SUBJECT: LA 6-200-C Model

DATE: December 30, 1935

ADJUSTMENT NOTES

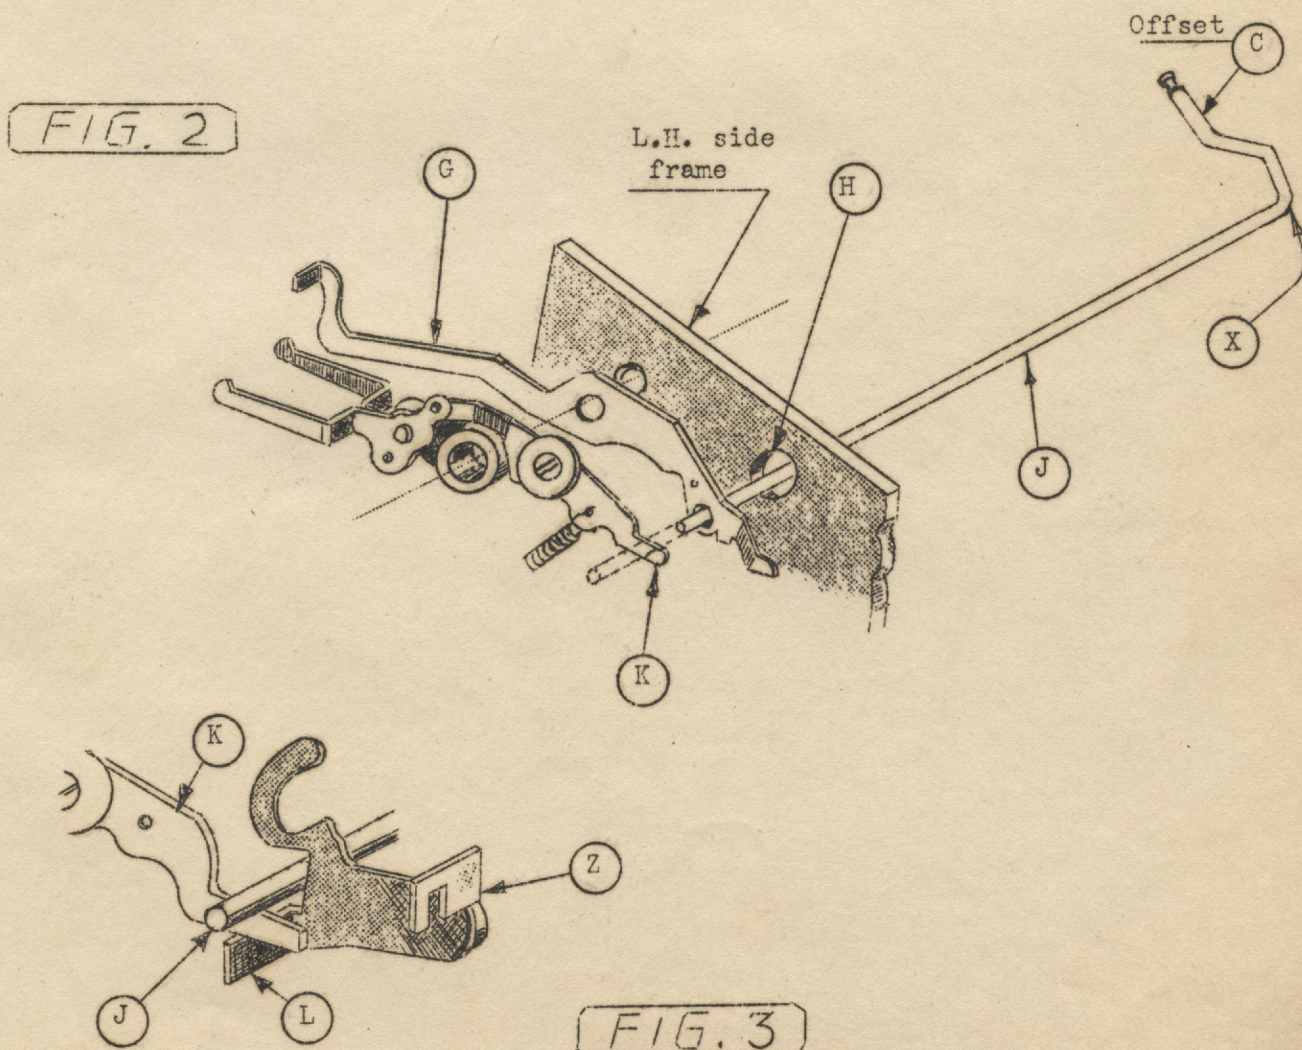
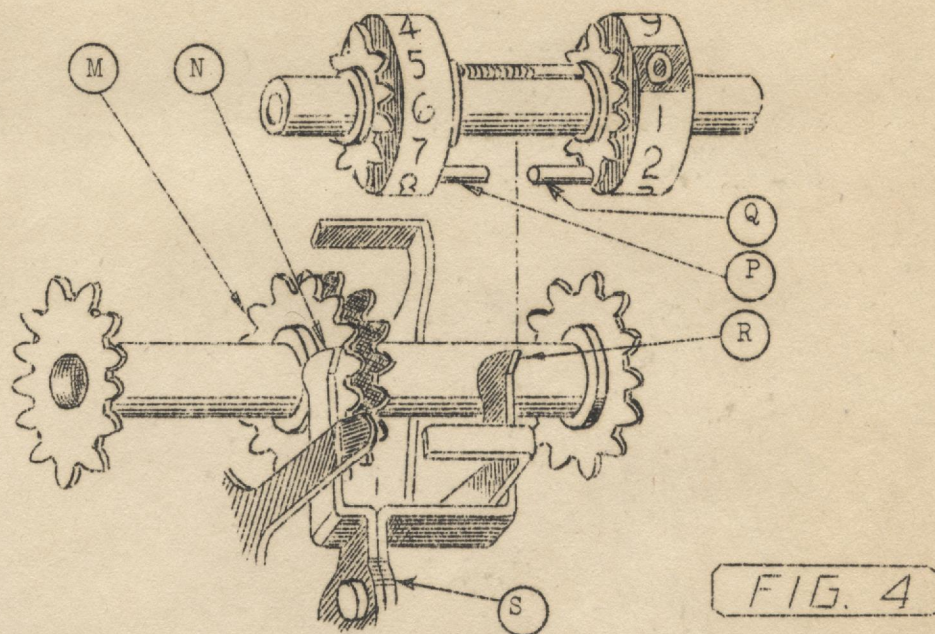
In addition to changes covered in Machine Service Bulletin No. 238, a change has also been made in the LA 6-200-C model whereby the machines will be equipped with a through-carry unit which does not contain trip levers 4310, trip lever shaft 4303 $\frac{1}{2}$ , overcarry trip lever 41-340 $\frac{1}{2}$ , screws 3007 or bearing 4309. Also a new trip lever 41-777x1 is used which is automatically disconnected during automatic multiplication by the use of a plunger rod. Long pins have been added to the 12th to 19th, inclusive, constant registering dial gears and a longer pin added to the last registering dial gear to compensate for the removal of the unit trip levers. A 47900 plunger engages the multiplication lever and extends through the side frames and the keyboard.

The left end of the plunger locates in a hole in a new style flexible end 41-779 which replaces the former 40-779, and also moves into engagement with the new 41-777x1 trip lever which replaces the 41-777. When the multiplication lever is returned to neutral, the trip lever is automatically coupled to the flexible end and serves as a regular trip lever when using the plus or minus bars or automatic division.

- 1 Stock has been removed from the 49070 counting finger (A) to avoid interference with the movement of the 47900 plunger rod. Figure 1.
- 2 If, after the trip lever (K) and the 41-776 guide bracket (Z) have been adjusted the plunger rod (J) should strike the inner side of the 41-777xl trip lever (K) instead of positioning over it as shown in Figure 3, remove stock from the top of lug (L) to suit.

- 3 If the plunger rod (J) does not withdraw from engagement with the trip lever (K) when the multiplication lever is positioned toward the rear of the machine, bend the offset (C) of the plunger rod inward at (X).

- 4 If the plunger rod (J) does not engage the trip lever (K) when the multiplication lever is in neutral, bend the offset (C) of the plunger (J) outward at (X).

- 5 Stock has been removed from the face of the hub on the 41-543xl trip rod locator to avoid interference with the long carry pin on the 20th dial. See Plate 4.

6. The outer prong (N) of the trip lever (S) should be adjusted as close as possible to the extra carry gear (M) without causing it to bind.
7. Care should be taken that the clearing pins (P) and the 41-527 carrying pins (Q) do not interfere with lug (R).
